Access Compliance Report

Public Rights-of-Way

(Curb Ramps)

Intersection ID: 21011	Main Street: CORONATION_BV	Cross Street: SARDIS_RD_NORTH	Location: NE
ADA ID: 2B2C844A3C89	Ramp Type: Perp	Initial Pass/Fail: Fail	Overall Compliance: No
Severity Score: 60			
Codes/Mitigation Info/Possible Solution		Field Measurements/Component Compliance

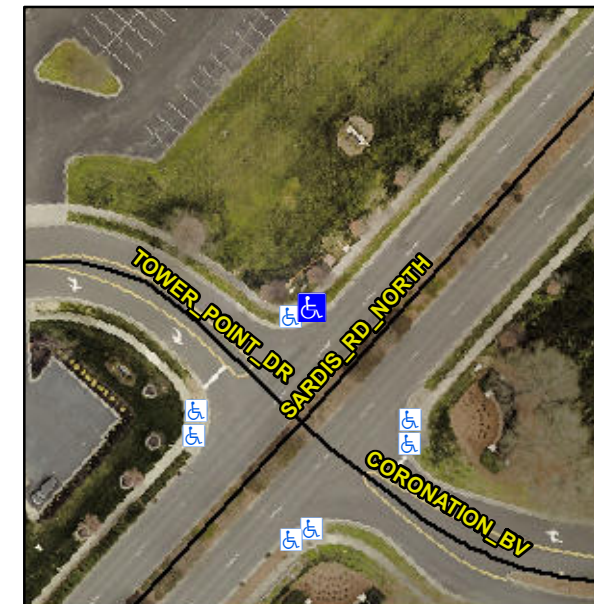
Not Found, R304.5.1, R304.2.2, R304.5.3

Compliance	Description	Data	Compliance	Description	Data
N/A	Ramp Length (in)	64.0	No	Ramp Slope (%)	8.5
No	Ramp Width (in)	31.0	No	Ramp XSlope (%)	5.7
N/A	Flare Type LT	N/A	N/A	Flare Type RT	N/A
N/A	Flare Slope LT (%)	N/A	N/A	Flare Slope RT (%)	N/A
N/A	Flare Traversable LT?	N/A	N/A	Flare Traversable RT?	N/A
N/A	Landing Length (in)	N/A	N/A	DWS Provided?	N/A
N/A	Landing Width (in)	N/A	N/A	DWS Contrast?	N/A
N/A	Landing Slope (%)	N/A	N/A	DWS Length (in)	N/A
N/A	Landing X Slope (%)	N/A	N/A	DWS Full Width?	N/A
N/A	Landing Curb? (Y/N)	N/A	N/A	DWS Offset (in)	N/A
N/A	Shared Landing?	N/A			
N/A	Gutter Ponding?	N/A	N/A	Gutter Slope (%)	N/A
N/A	Gutter Lip Ht (in)	N/A	N/A	Gutter X Slope (%)	N/A
N/A	Painted X Walk1?	No	N/A	Painted X Walk2?	N/A
	X Walk 1 Direction	To SE		X Walk 2 Direction	N/A
N/A	X Walk 1 Width (in)	N/A	N/A	X Walk 2 Width (in)	N/A
	X Walk 1 Slope (%)	1.3		X Walk 2 Slope (%)	N/A
	X Walk 1 X Slope (%)	6.4		X Walk 2 X Slope (%)	N/A

Remove & Replace Entire Ramp.
